Access Compliance Report Public Rights-of-Way (Curb Ramps)

Main Street: NEWPORT_AVE Cross Street: LA_LOMA_DR Location: W

ADA ID: RPRK211008143020 Ramp Type: Type 1 - Perpendicular Diagonal Initial Pass/Fail: Fail Overall Compliance: No Severity Score: 34

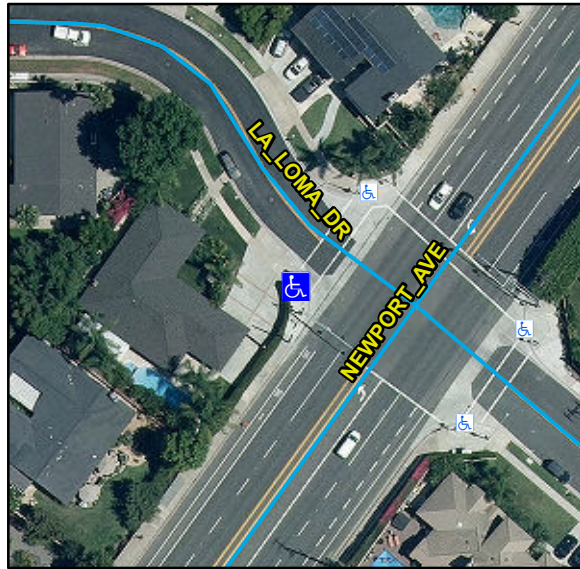
R304.2.2, R304.5.1, R304.5.3, STD 1115

Remove & Replace Curb Ramp With Two New Directional Ramps or Equivalent.
